PERMITTED DRAWING
(PROVIDED FOR RECORD PURPOSES ONLY)
SDCC GRANTED PLANNING REGISTER
REFERENCE No. SD22A/0092

Drawing Status: PLANNING ALTERATION GRANTED

Job Title: DEVELOPMENT AT SITE C, COLLEGE LANE, GREENOGUE RATHCOOLE CO. DUBLIN

Drawing Title: ELEVATIONS

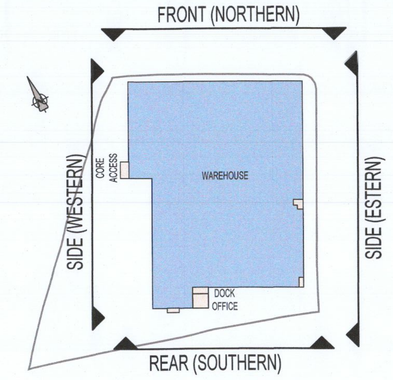
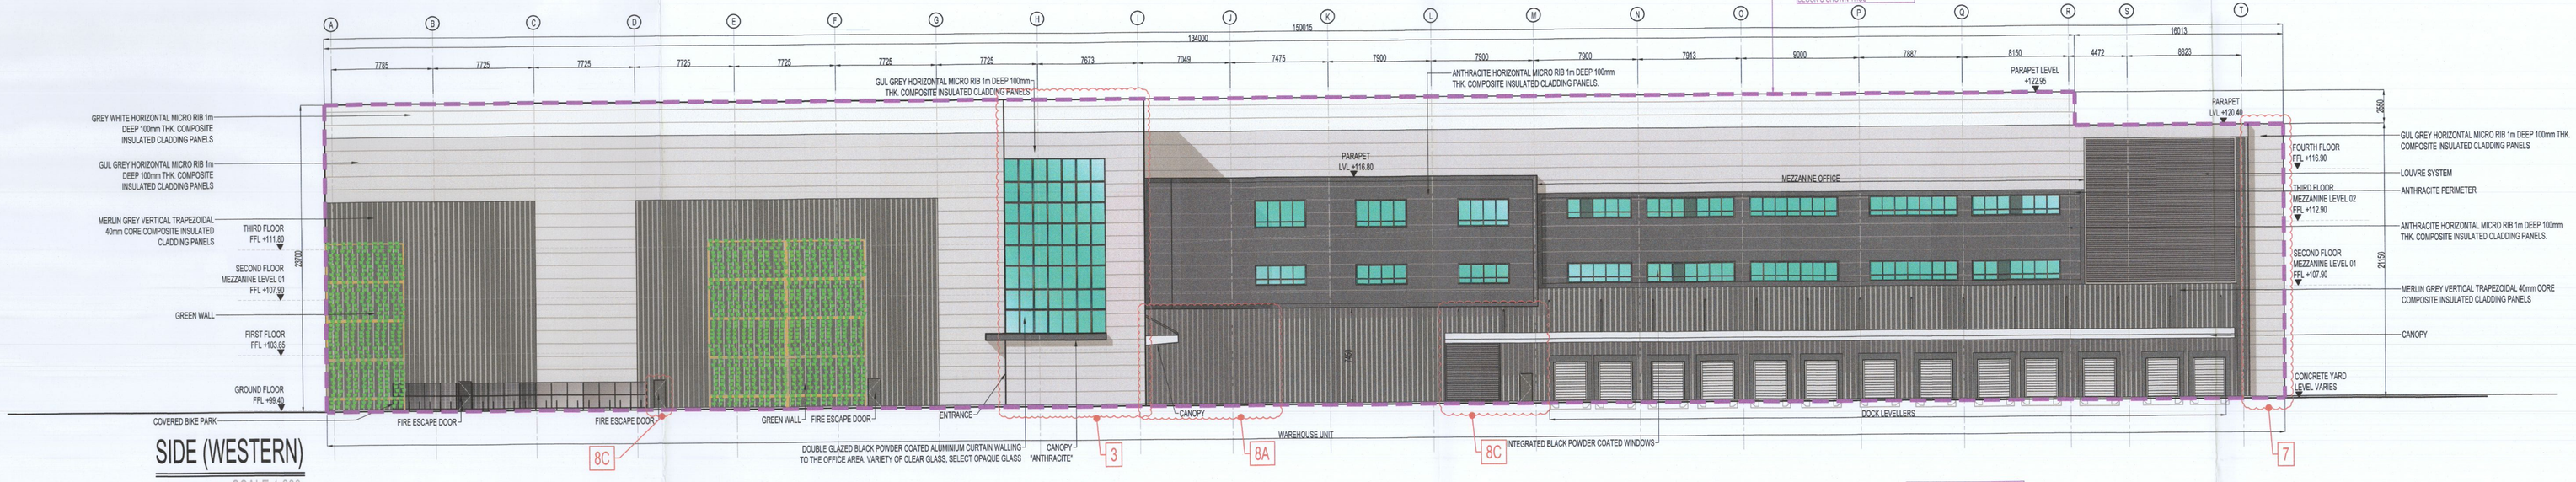
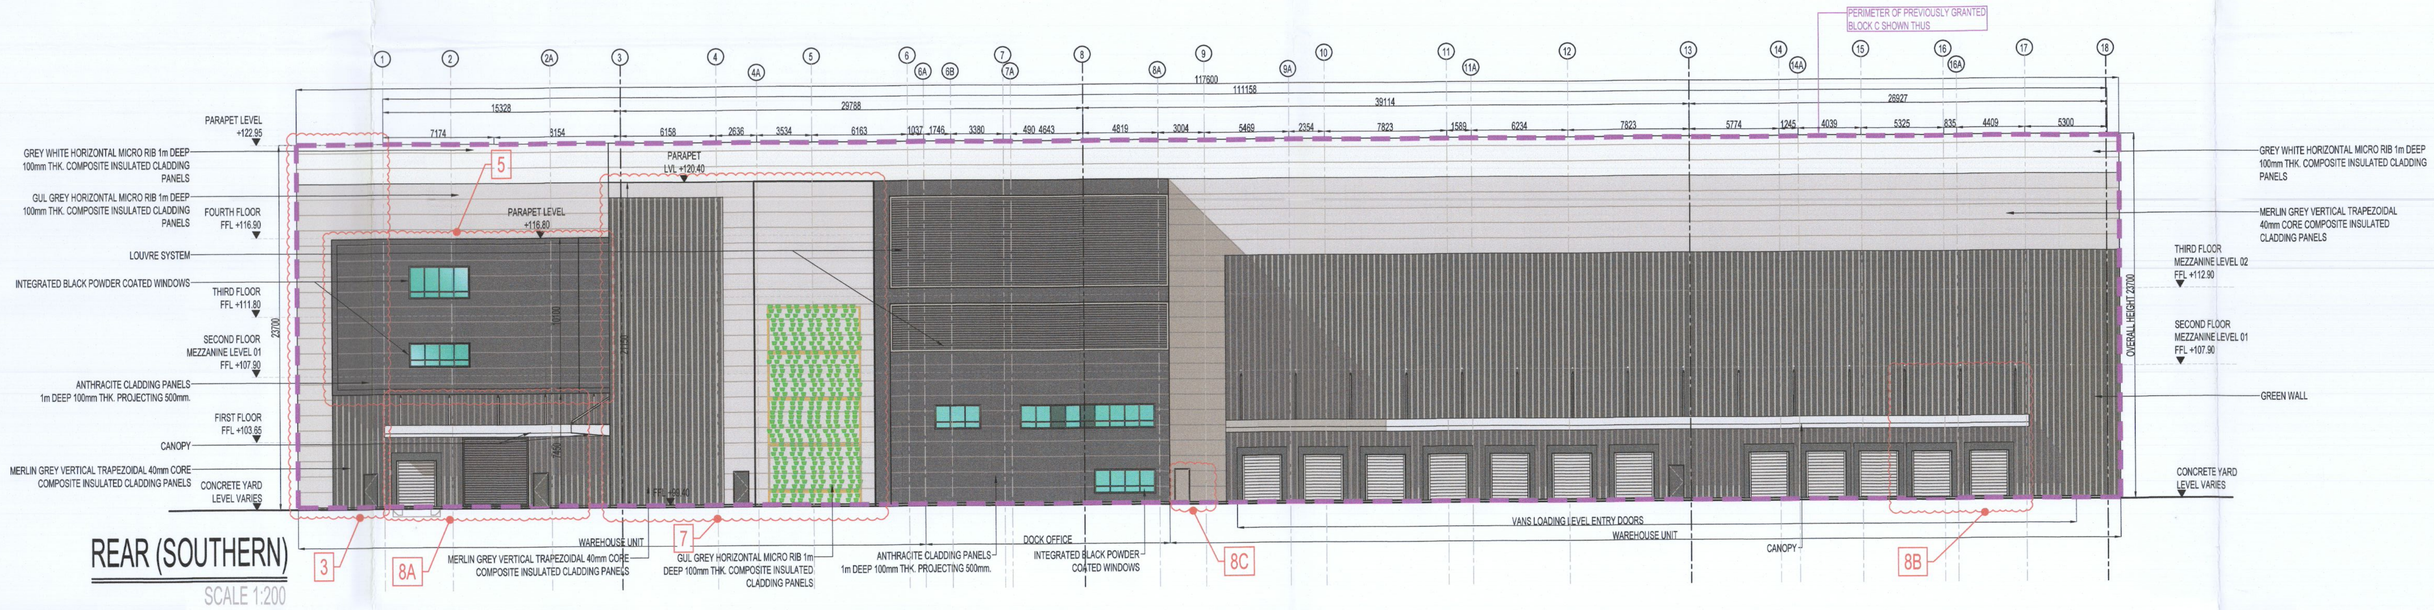
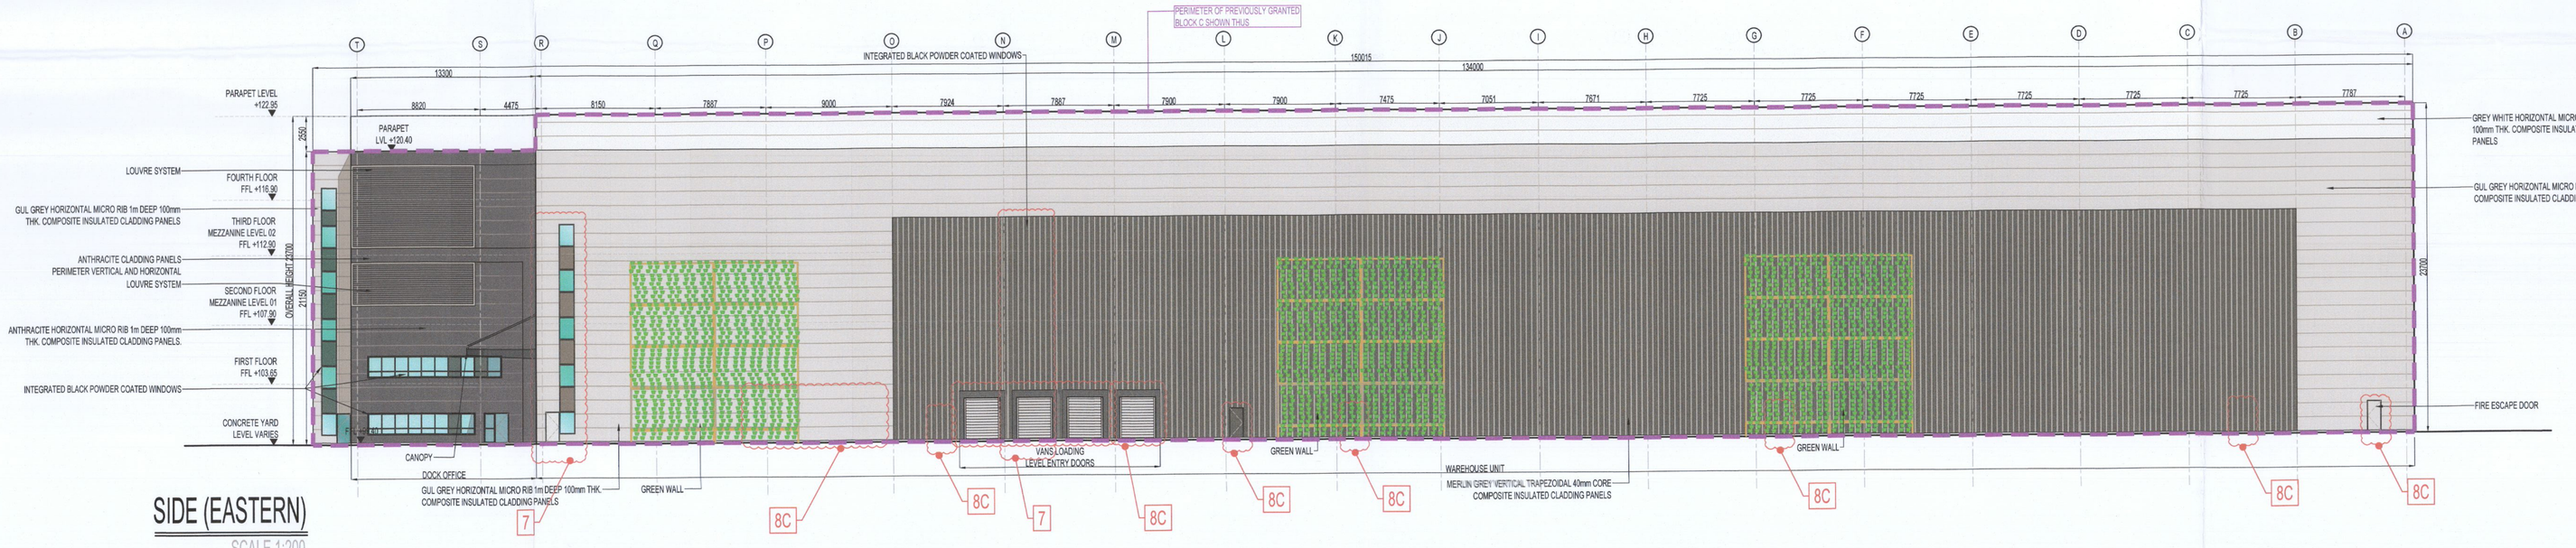
8 — Associated elevational changes:

- A — Relocation of dock leveller & level access door with associated canopy from building's north-west to south-west elevation.
- B — Addition of 2 no. level access van doors with associated canopy to the building's rear (southern) elevation.
- C — Relocation of level entry goods doors and fire exit doors throughout the building.
